TECHNICAL BULLETIN

[Issue No.] GOT-A-0158

[Title] Change of Applicable Safety Standards and Specifications

[Relevant Models] MELIPC Series

3.2 Removal of the catch(es) and pins

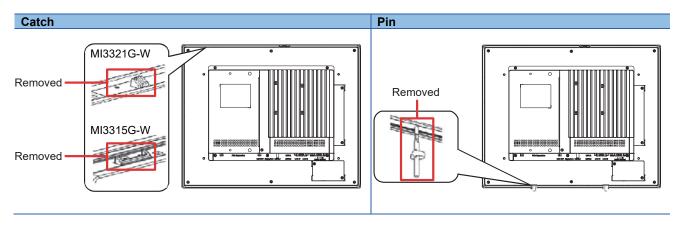
The upper catch(es) and the lower pins to temporarily fasten the product to the control panel will be removed.

3.3 Change of the rear case design

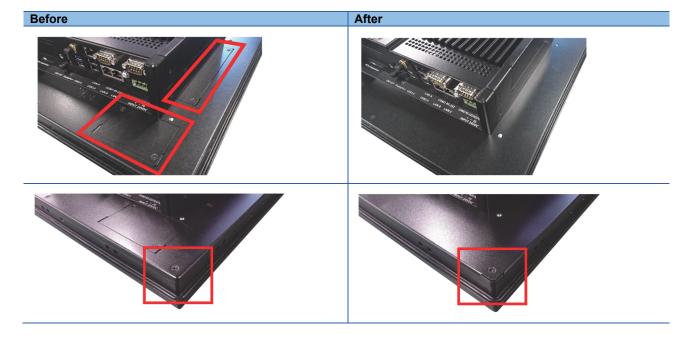
The rear case design of the LCD module unit will be changed.

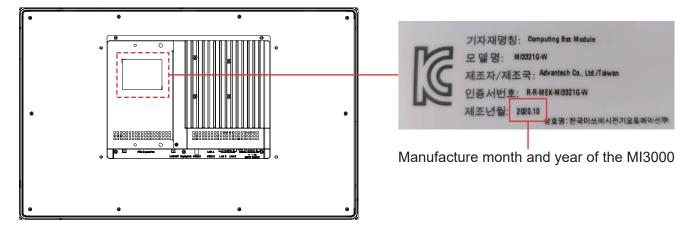
4. How to identify the new products
The new LCD module unit will be used for the products manufactured in December 2020 and later. Check the rating plate for the manufacture month and year.
